**RE: National Energy Board (NEB)
British Columbia Hydro and Power Authority (BC Hydro)
Application to the NEB to Vary Certificate of Public Convenience and
Necessity No. EC-51 (Application)
NEB File OF-Fac-IPL-B215-2017-01 01
BC Hydro Responses to NEB Information Request No. 3**

National Energy Board Information Request No. 3.1.a Dated: October 19, 2017 British Columbia Hydro & Power Authority Response issued October 26, 2017	Page 1 of 3
British Columbia Hydro & Power Authority Application for the Variance of Certificate of Public Convenience and Necessity (CPCN) EC-51 NEB File OF-Fac-IPL-B215-2017-01 01

3.1 Determination of an Appropriate Termination Point of the International Power Line (IPL)

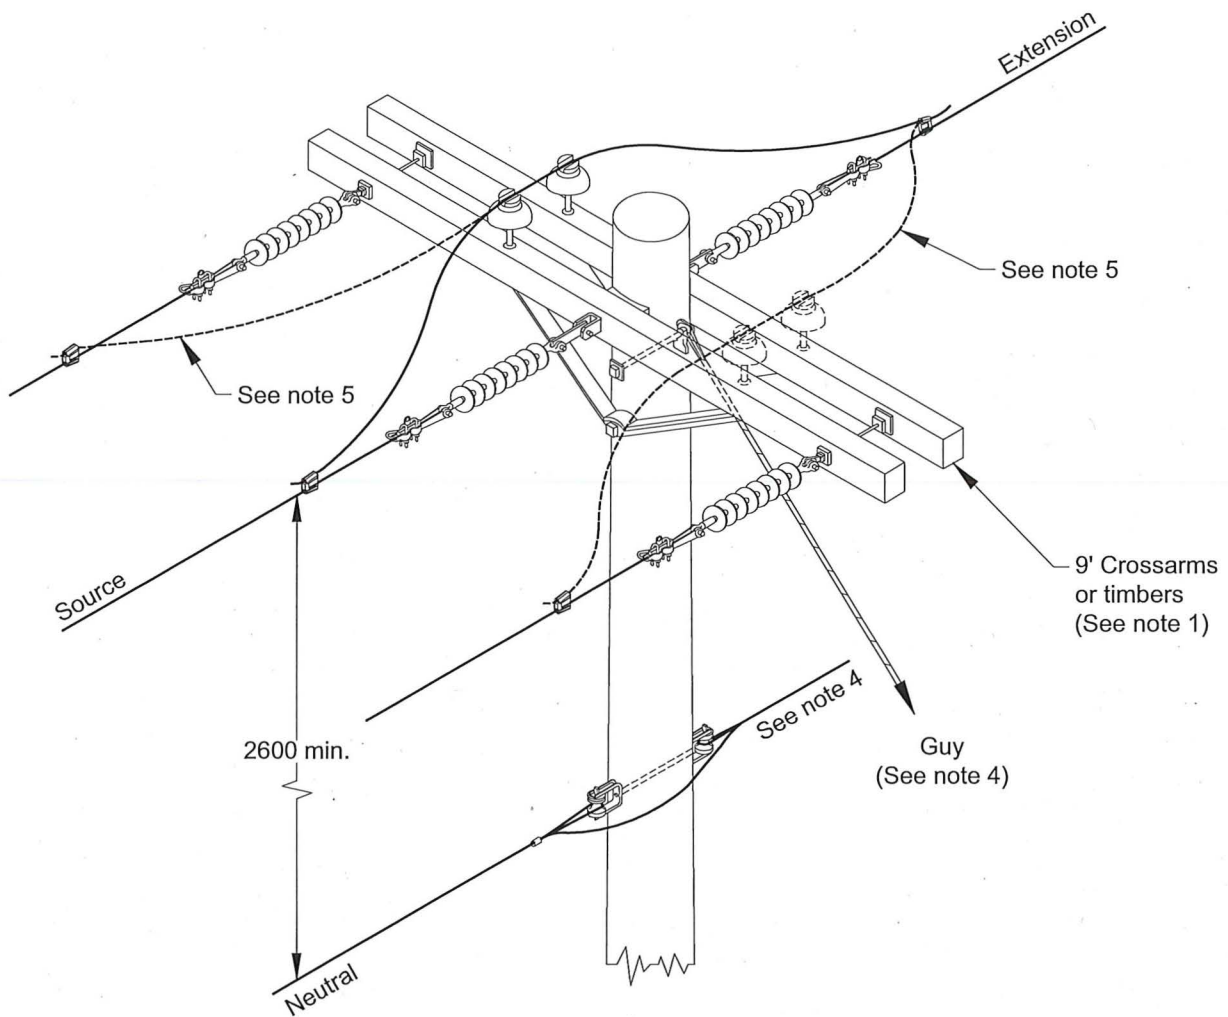
- b) a 3D drawing illustrating the configuration of the Pole 013; and,

A 3D drawing illustrating the configuration of Pole 013 is included as Attachment 1.

As discussed in BC Hydro's response to NEB IR 3.1.a Pole 014 would be the termination pole of the 25 kV three-phase system. Pole 014 would have the configuration shown on the 3D standard drawing ES43 G4-05.03 included as Attachment 2.
